UNITED STATES PATENT AND TRADEMARK OFFICE

APPLICATION NO.	FILING DATE	FIRST NAMED INVENTOR	ATTORNEY DOCKET NO.	CONFIRMATION NO.
10/801,265	03/16/2004	Jean-Paul Bonnet	1055-04	4747

Office Action Summary	Application No. 10/801,265	Applicant(s) BONNET ET AL.	
	Examiner William H. Rodriguez	Art Unit 3746

DETAILED ACTION

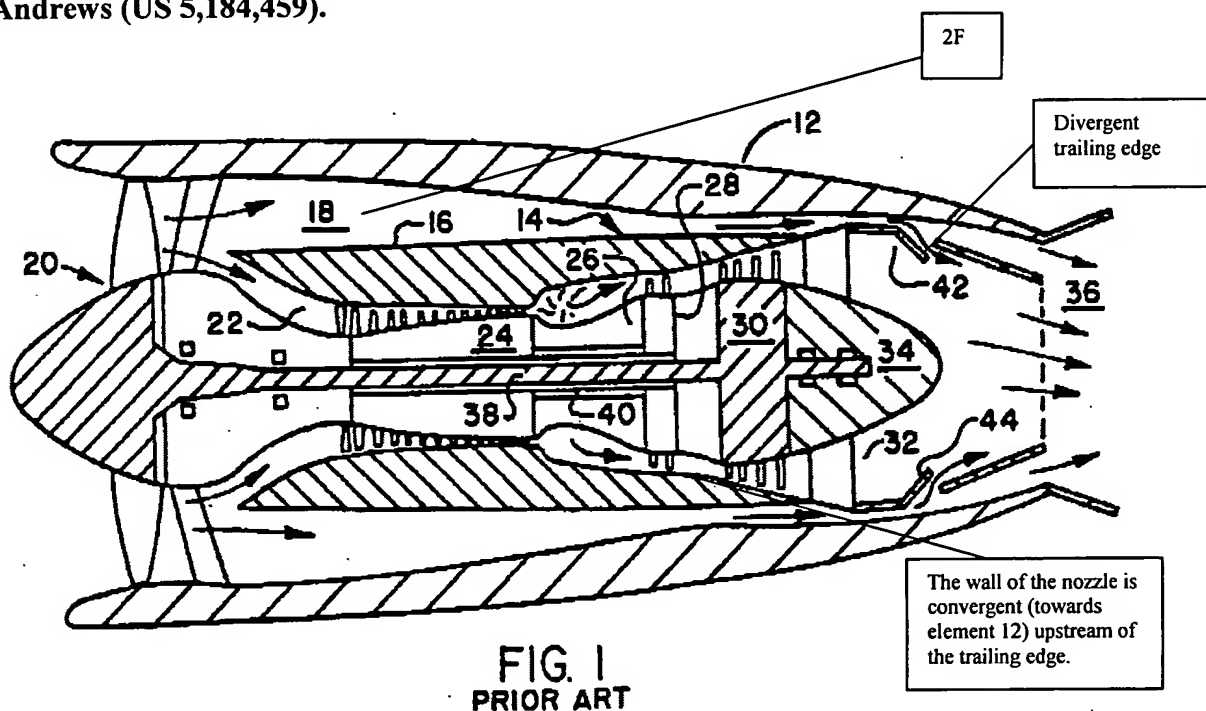
With respect to claim 1, McAndrews teaches an engine having a device 42, 44 for controlling propulsive gas mixing at an outlet of said engine, wherein propulsive jets are composed of a hot primary jet exiting from a nozzle of the engine and a secondary flux (2F) flowing between an external wall of the nozzle and an internal wall of the engine, the device comprising: a divergent trailing edge* on the wall that generates conditions of a separation of the primary jet and a primary jet controller (not show but mentioned, column 3 lines 35, 39) that

enables control of passage of the primary jet from a separated state to a reattached state, and vice versa. See particularly **Figure 1** of McAndrews above.

*Diverging the primary jet towards a central axis of the engine, away from the wall of the nozzle.

With respect to claim 2, **McAndrews** teaches that controlling the separation of the primary jet is periodic (elements 42, 44 open and close periodically depending on the mode of operation). See particularly **Figure 1** of McAndrews above.

With respect to claim 11, **McAndrews** teaches that control of the separation of the primary jet is implemented at the trailing edge. See particularly **Figure 1** of McAndrews above.

With respect to claim 12, **McAndrews** teaches that control of the separation of the primary jet is implemented to generate a symmetrical flow at the outlet of the engine. See particularly **Figure 1** of McAndrews above.

With respect to claim 13, **McAndrews** teaches that the trailing edge has an angle with the wall of the nozzle between about 10 and about 30.degree. See particularly **Figure 1** of McAndrews above.

With respect to claim 14, **McAndrews** teaches that the wall of the nozzle is convergent upstream of the trailing edge. See particularly **Figure 1** of McAndrews above.

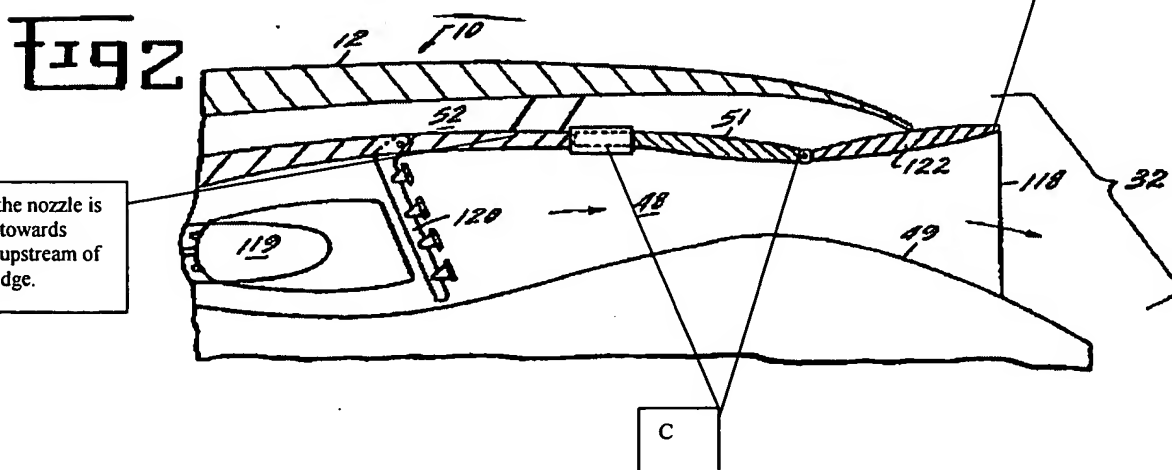
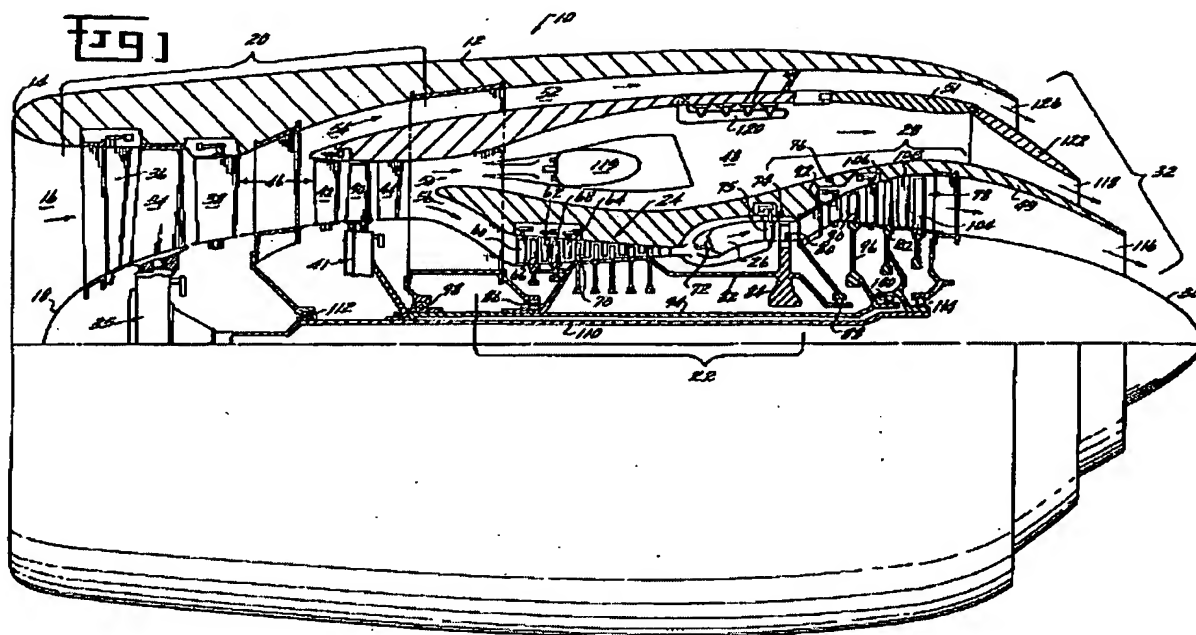
The wall of the nozzle is convergent (towards element 12) upstream of the trailing edge.

Divergent trailing edge

With respect to claim 1, **Koff** teaches an engine having a device 122 for controlling propulsive gas mixing at an outlet of said engine, wherein propulsive jets are composed of a hot primary jet exiting from a nozzle of the engine and a secondary flux (52) flowing between an external wall of the nozzle and an internal wall of the engine, the device comprising: a divergent trailing edge* on the wall that generates conditions of a separation of the primary jet and a primary jet controller (C) that enables control of passage of the primary jet from a separated state to a reattached state, and vice versa. See particularly **Figures 1, 2** of Koff above.

*Diverging the primary jet away from a central axis of the engine

With respect to claim 2, **Koff** teaches that controlling the separation of the primary jet is periodic (element 122 opens and close periodically depending on the mode of operation). See particularly **Figures 1, 2** of Koff above.

With respect to claim 9, **Koff** teaches that the controller C is arranged on all or a part of the circumference of the internal wall of the nozzle. See particularly **Figures 1, 2** of Koff above.

With respect to claim 10, **Koff** teaches that the controller C is arranged on all or a part of the circumference of the external wall of the nozzle. See particularly **Figures 1, 2** of Koff above.

With respect to claim 11, **Koff** teaches that control of the separation of the primary jet is implemented at the trailing edge. See particularly **Figures 1, 2** of Koff above.

With respect to claim 12, **Koff** teaches that control of the separation of the primary jet is implemented to generate a symmetrical flow at the outlet of the engine. See particularly **Figures 1, 2** of Koff above.

With respect to claim 13, **Koff** teaches that the trailing edge has an angle with the wall of the nozzle between about 10 and about 30.degree. See particularly **Figures 1, 2** of Koff above.

With respect to claim 14, **Koff** teaches that the wall of the nozzle is convergent upstream of the trailing edge. See particularly **Figures 1, 2** of **Koff** above.

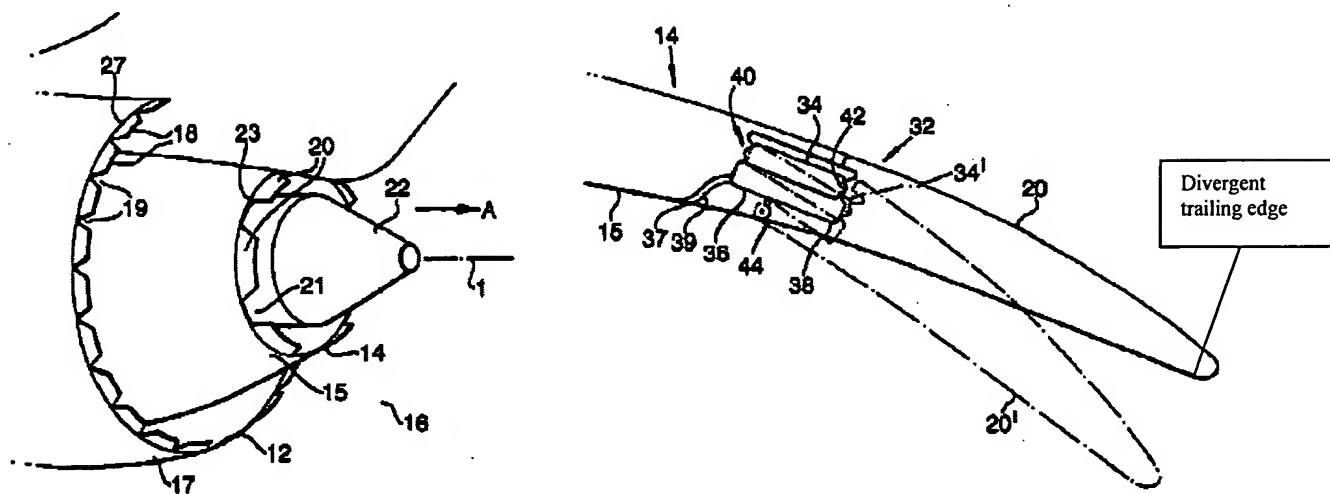
With respect to claim 1, **Birch** teaches an engine having a device 20 for controlling propulsive gas mixing at an outlet of said engine, wherein propulsive jets are composed of a hot primary jet exiting from a nozzle of the engine and a secondary flux flowing between an external wall of the nozzle and an internal wall of the engine, the device comprising: a divergent trailing edge* on the wall that generates conditions of a separation of the primary jet and a primary jet controller (34) that enables control of passage of the primary jet from a separated state to a reattached state, and vice versa. See particularly **Figures 2, 5** of **Birch** above.

*Diverging the primary jet towards a central axis of the engine, away from the wall of the nozzle.

With respect to claim 2, **Birch** teaches that controlling the separation of the primary jet is periodic (element 20 opens and close periodically depending on the mode of operation). See particularly **Figures 2, 5** of Birch above.

With respect to claim 9, **Birch** teaches that the controller C is arranged on all or a part of the circumference of the internal wall of the nozzle. See particularly **Figures 2, 5** of Birch above.

With respect to claim 11, **Birch** teaches that control of the separation of the primary jet is implemented at the trailing edge. See particularly **Figures 2, 5** of Birch above.

With respect to claim 12, **Birch** teaches that control of the separation of the primary jet is implemented to generate a symmetrical flow at the outlet of the engine. See particularly **Figures 2, 5** of Birch above.

With respect to claim 13, **Birch** teaches that the trailing edge has an angle with the wall of the nozzle between about 10 and about 30.degree. See particularly **Figures 2, 5** of Birch above.
